PROPOSAL, CONTRACT, BOND AND SPECIFICATIONS

PHEASANT BRANCH GREENWAY ENHANCEMENT

CONTRACT NO. 9517

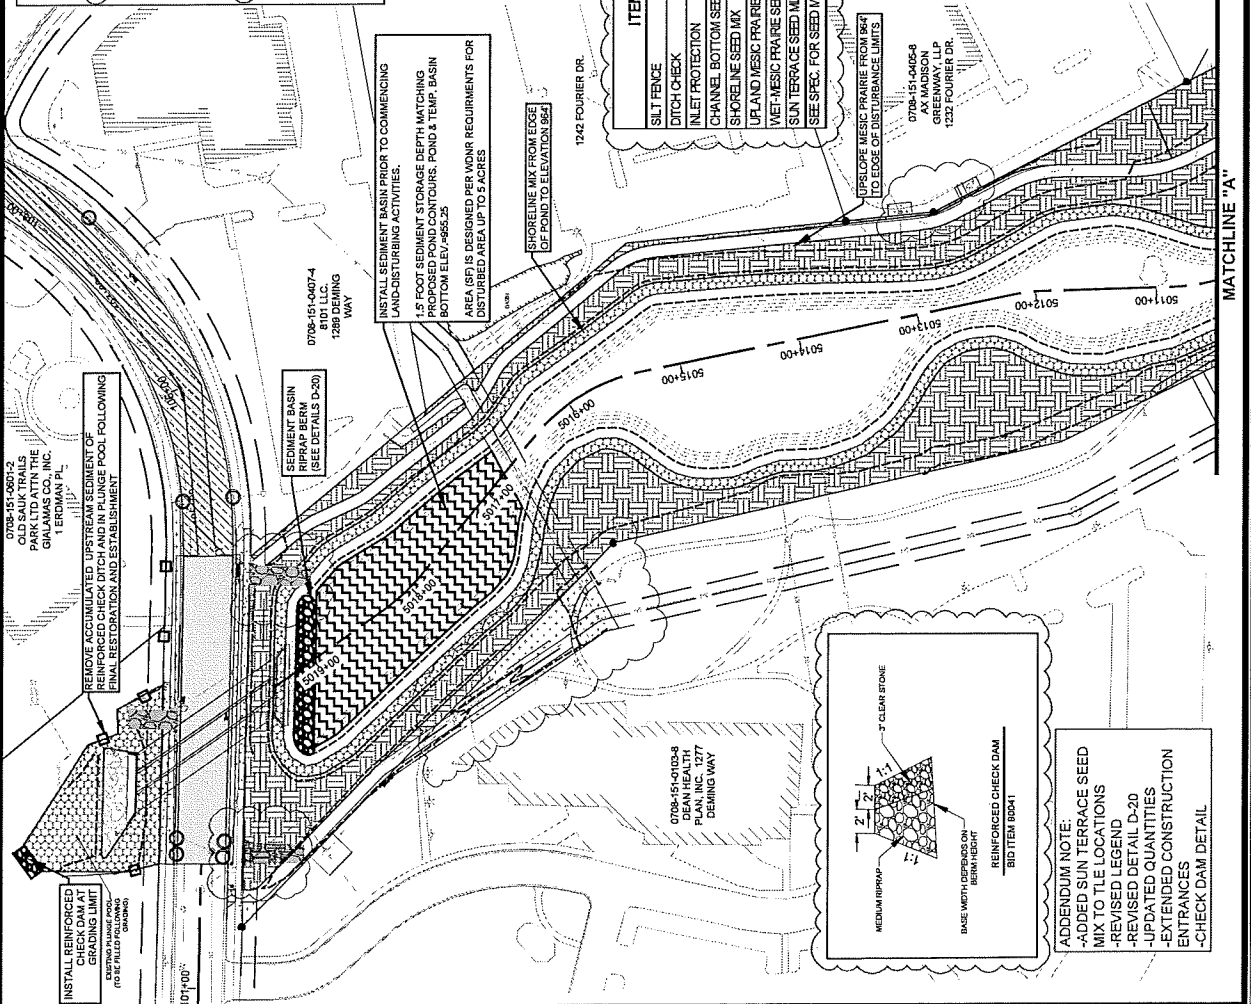
**ADDENDUM NOTE:**  
 -ADDED SUN TERRACE SEED MIX TO TILE LOCATIONS  
 -REVISED LEGEND  
 -UPDATED QUANTITIES  
 -CHECK DAM DETAIL

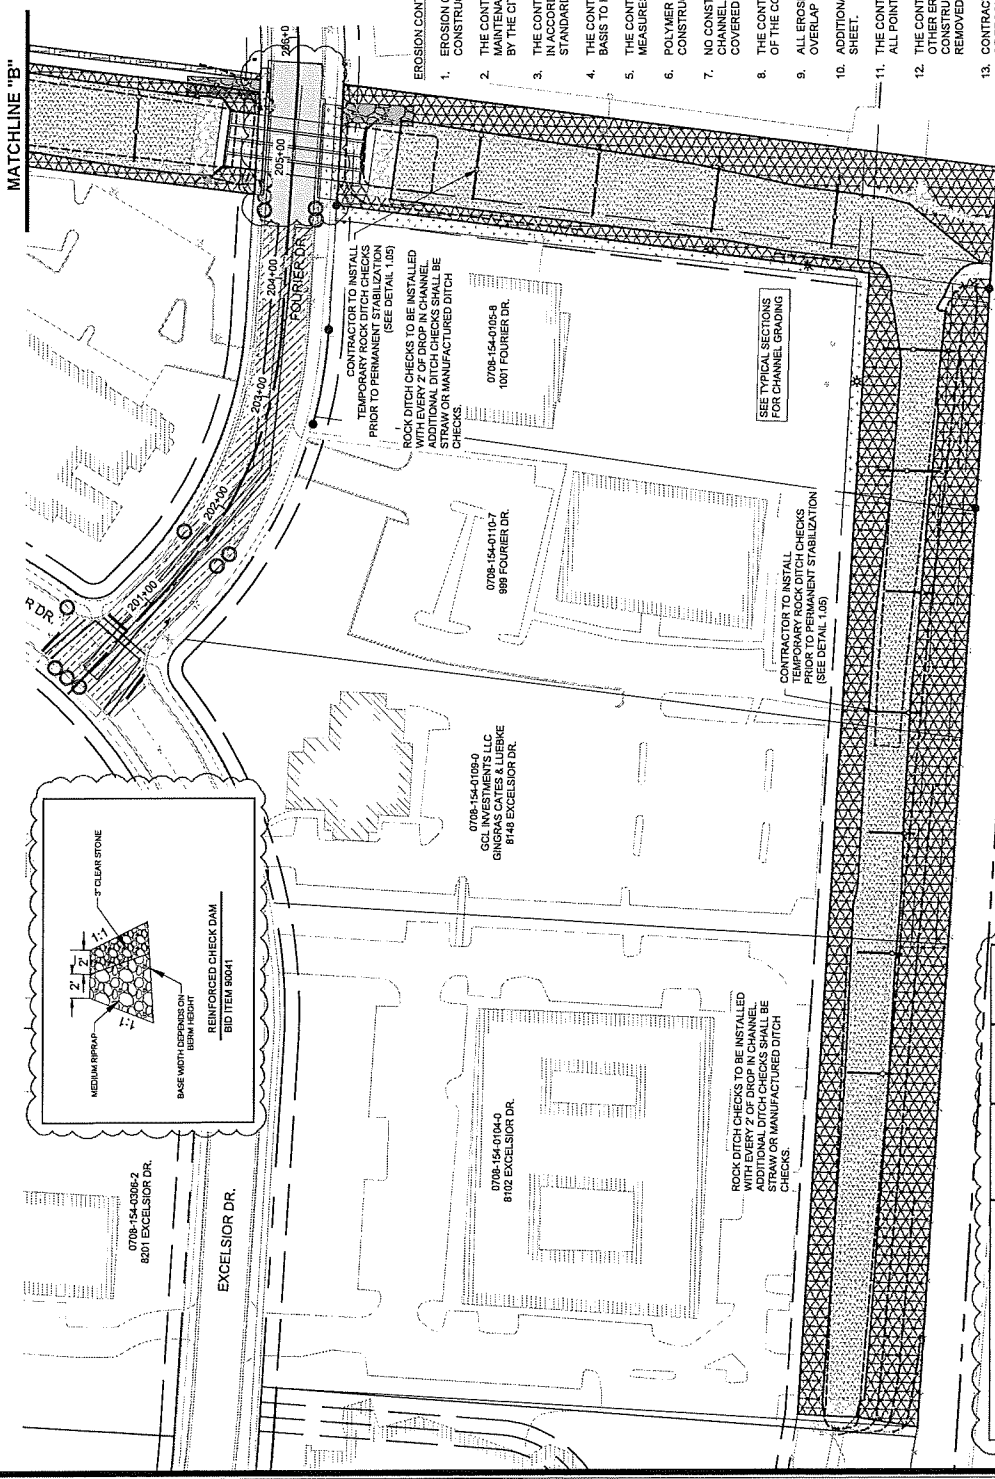
**APPENDIX NOTE:**  
 -ADDED SUN TERRACE SEED MIX TO TERRACE LOCATIONS  
 -REVISED LEGEND  
 -UPDATED QUANTITIES  
 -CHECK DAM DETAIL

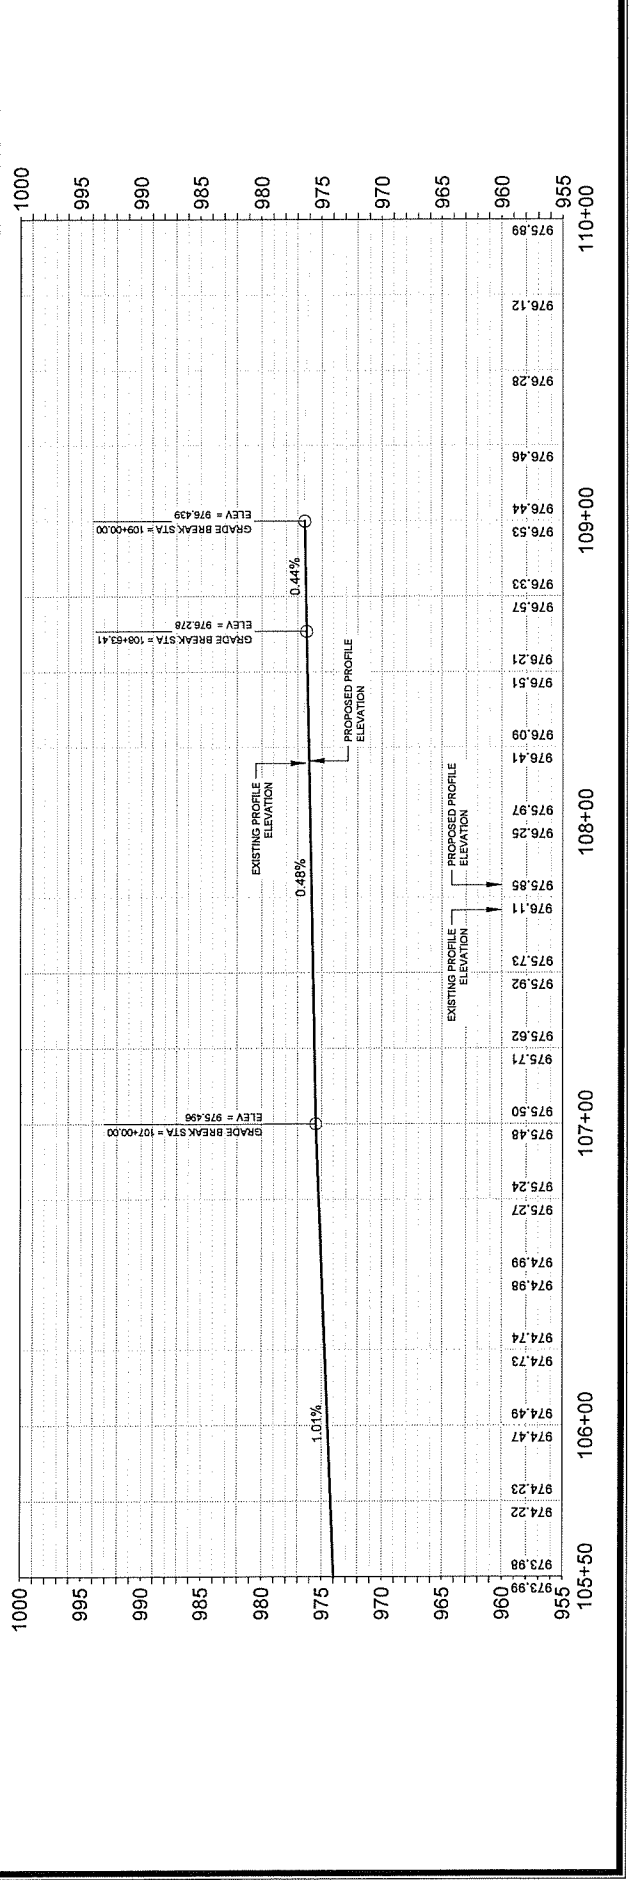
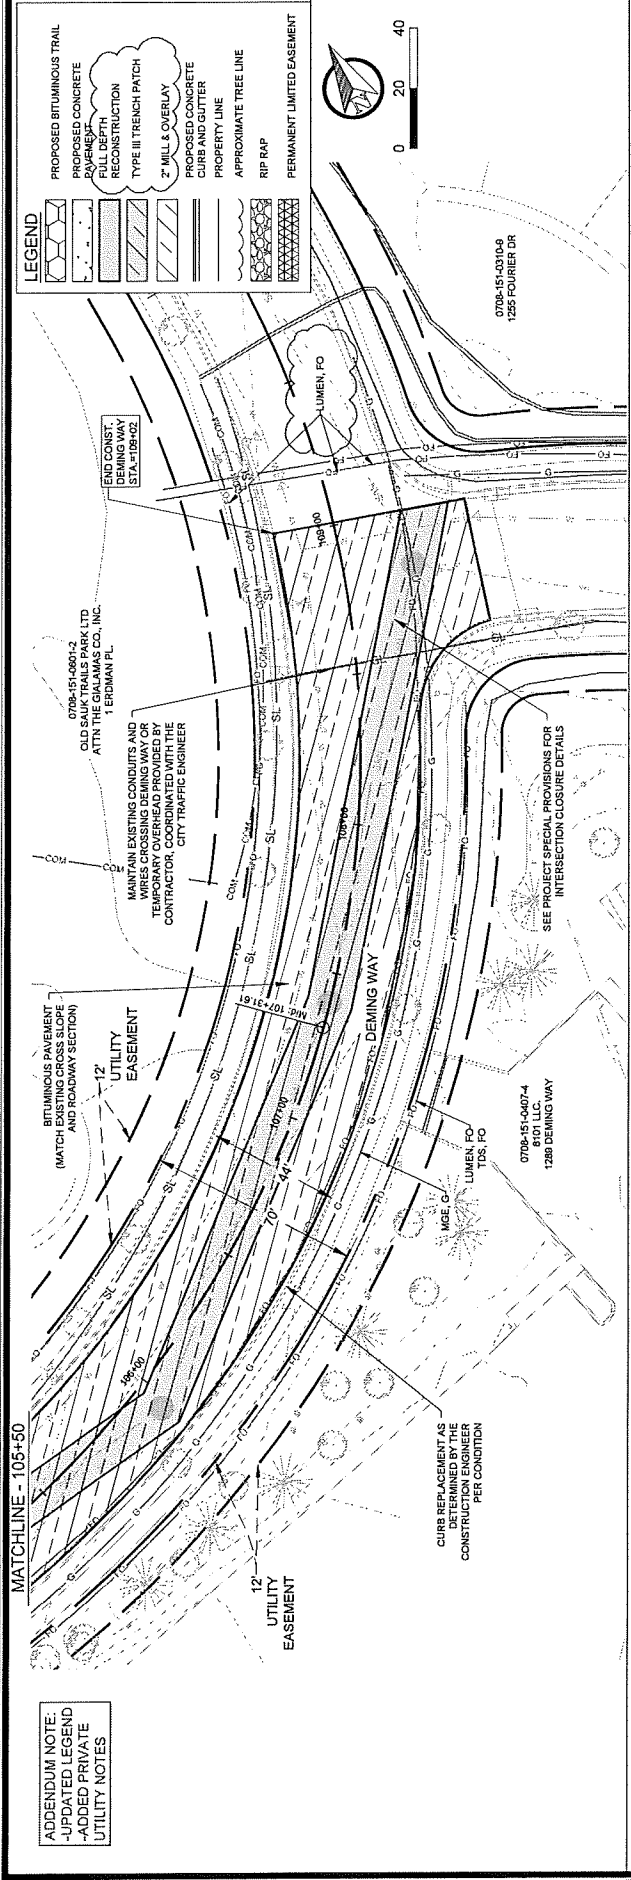
**ADDENDUM NOTE:**  
 -GRADE BREAK LABEL ADDED  
 -ADJUST SAWCUT LABEL  
 -ADDED DETECTABLE WARNING  
 -UPDATED LEGEND  
 -ADDED CURB RAMP LABEL  
 -PRIVATE UTILITY LABEL

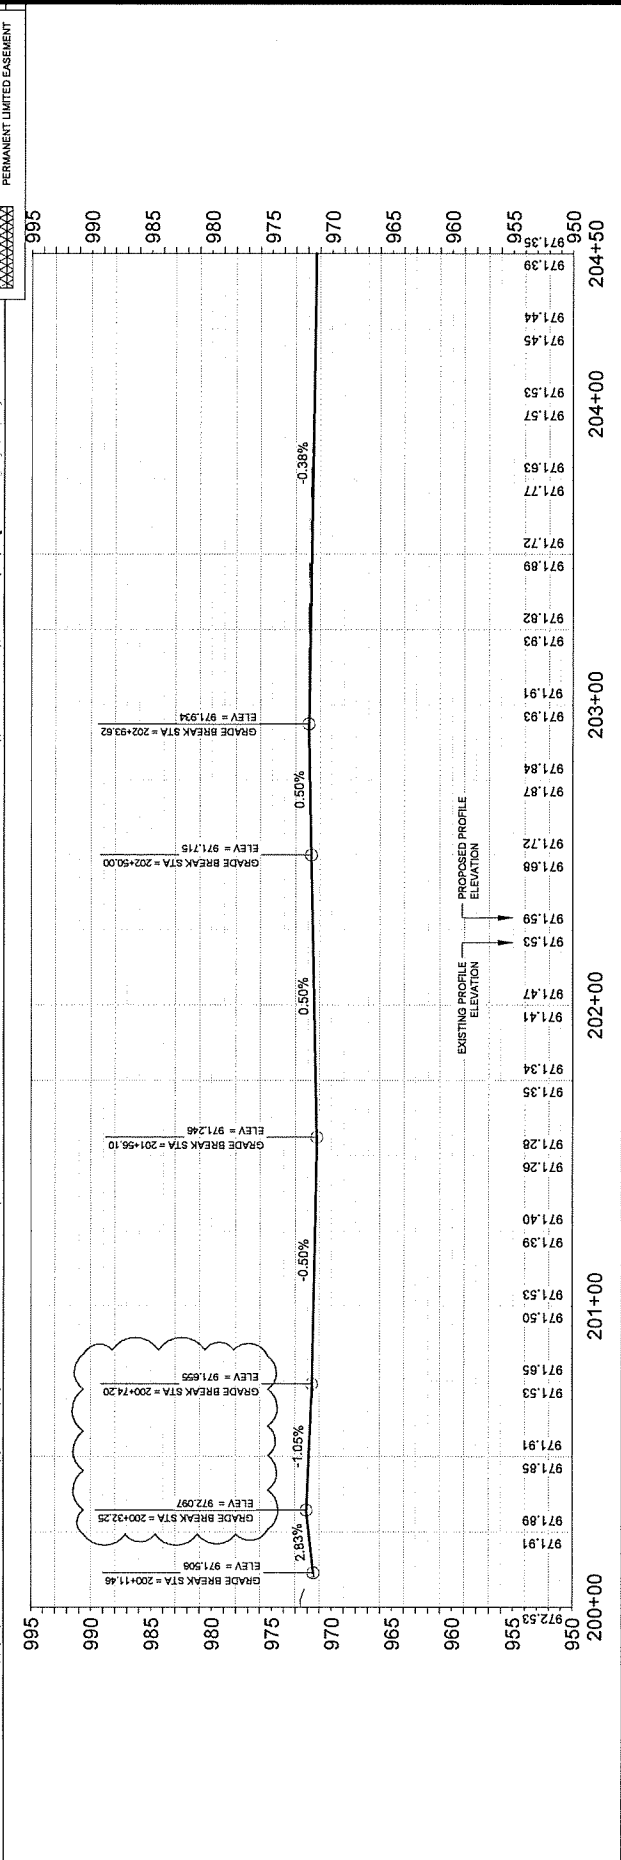
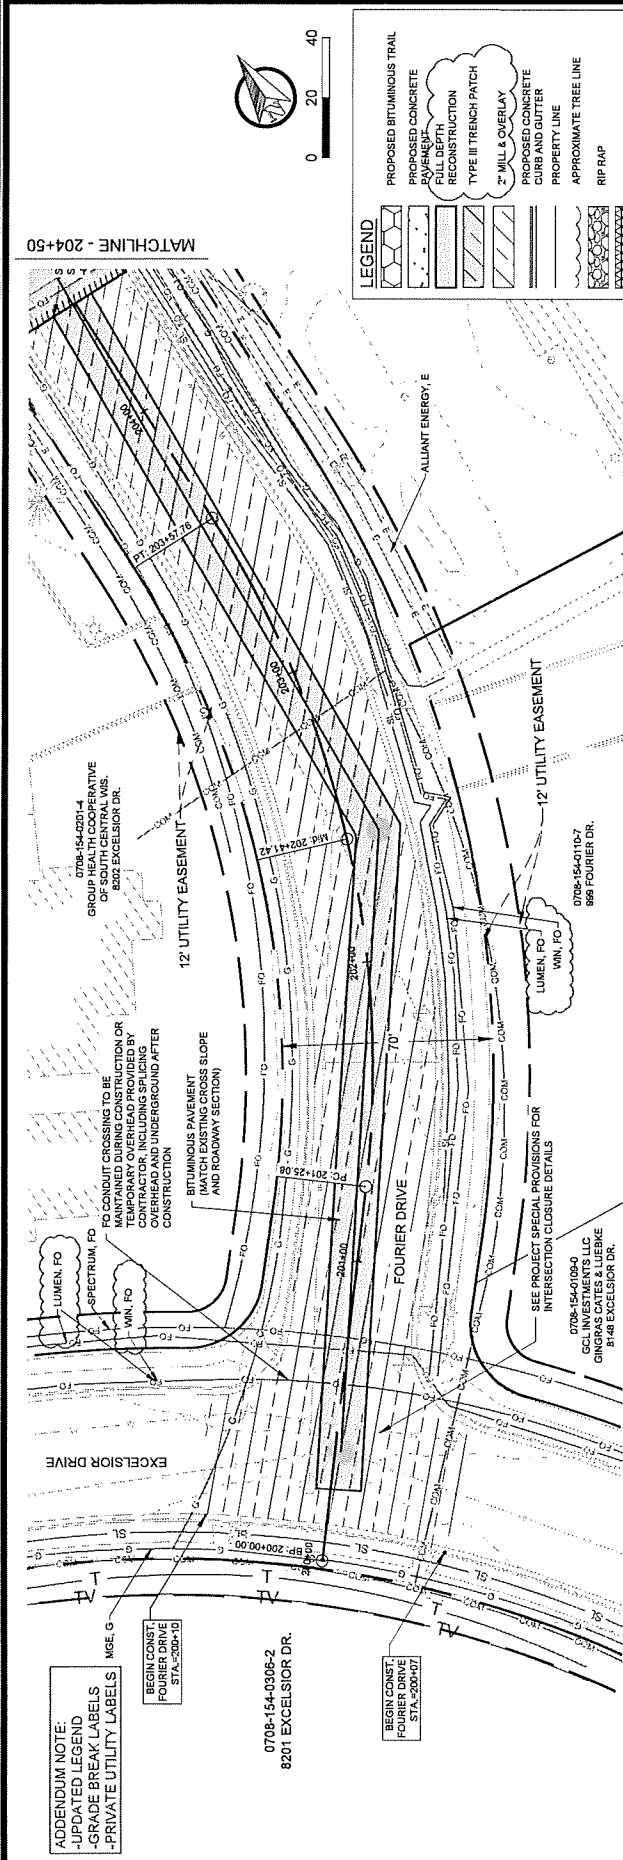
ADDENDUM NOTE:  
 -UPDATED LEGEND  
 -ADDED PRIVATE UTILITY NOTES

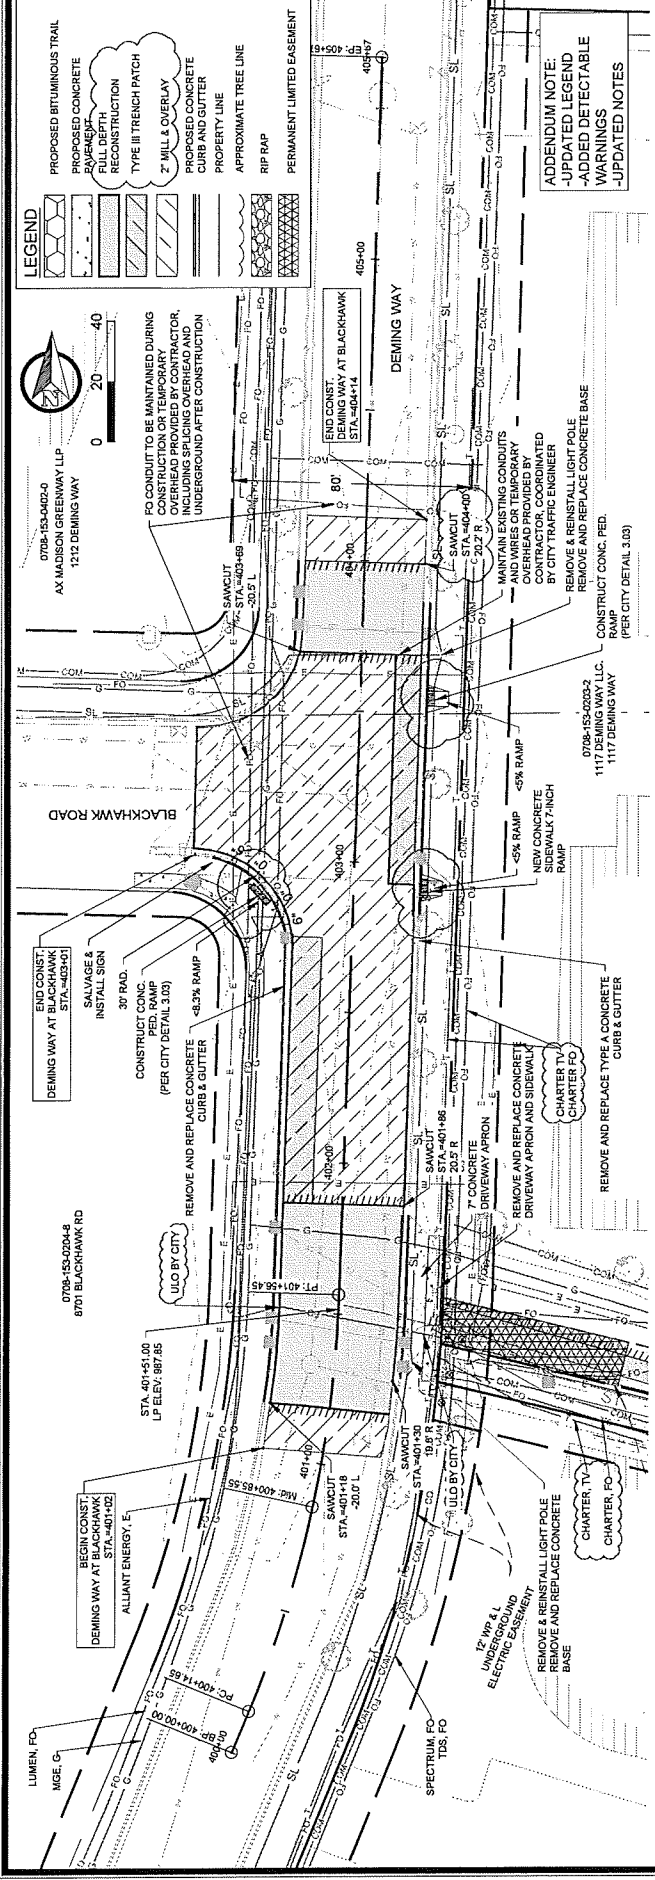
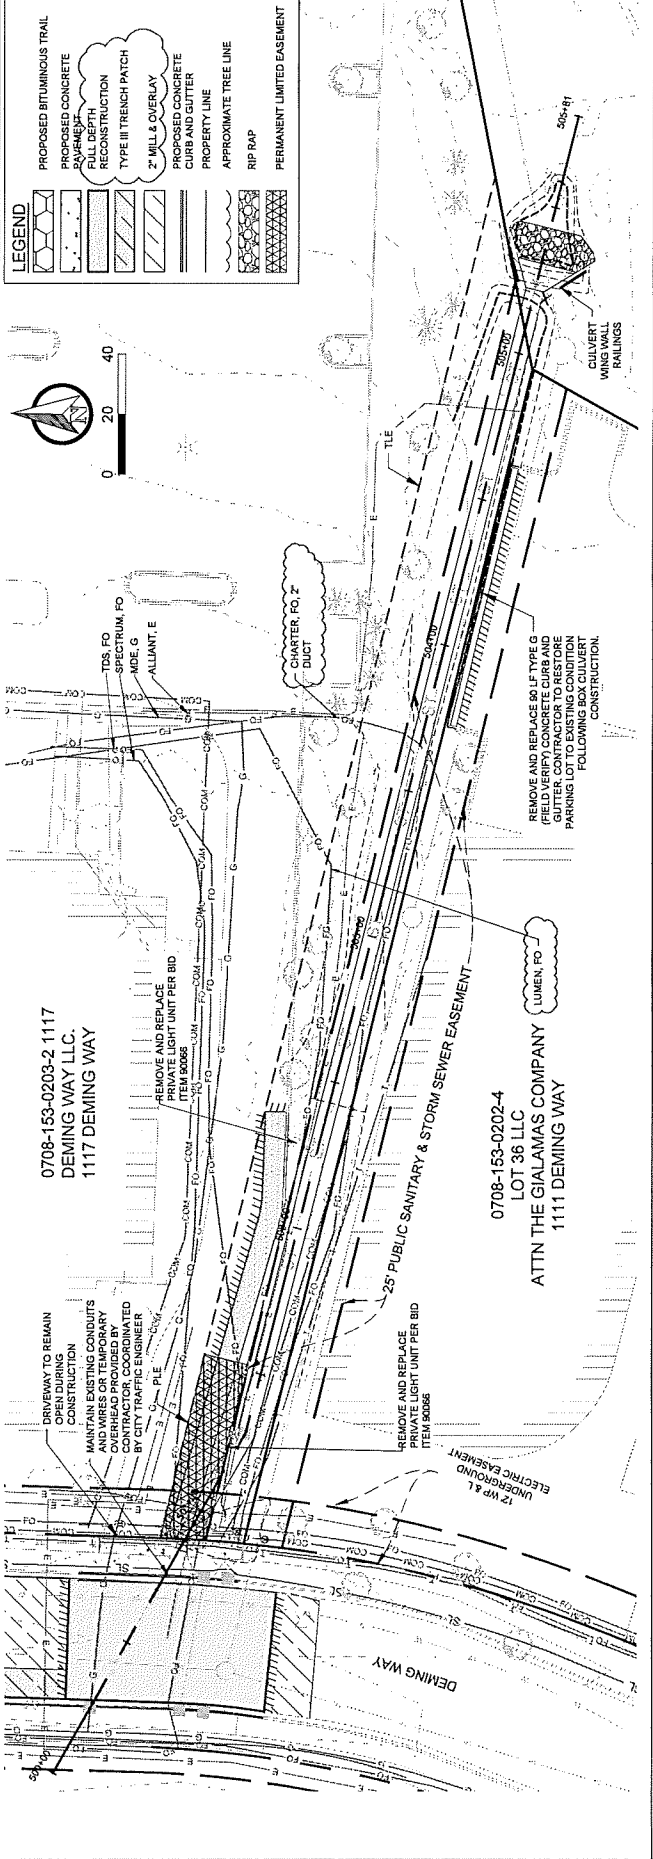
ADDENDUM NOTE:  
 -UPDATED LEGEND  
 -WARNING  
 -PRIVATE UTILITY LABELS

14370  
P17

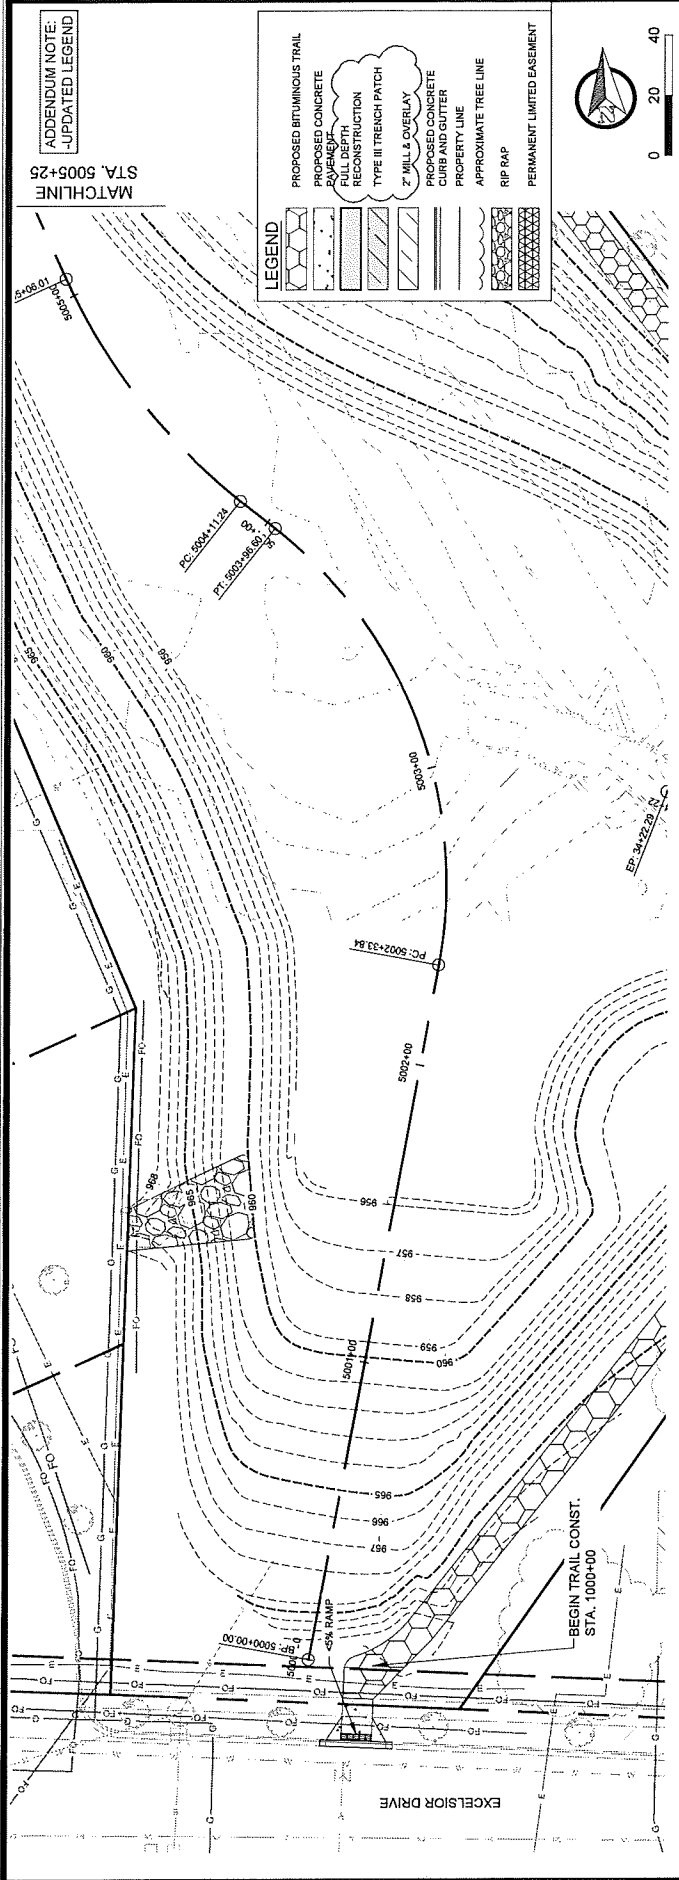
ADDENDUM NOTE:  
 -UPDATED LEGEND  
 -ADDED GRADE BREAK LABELS  
 -MODIFIED PROPOSED TRAIL PROFILE
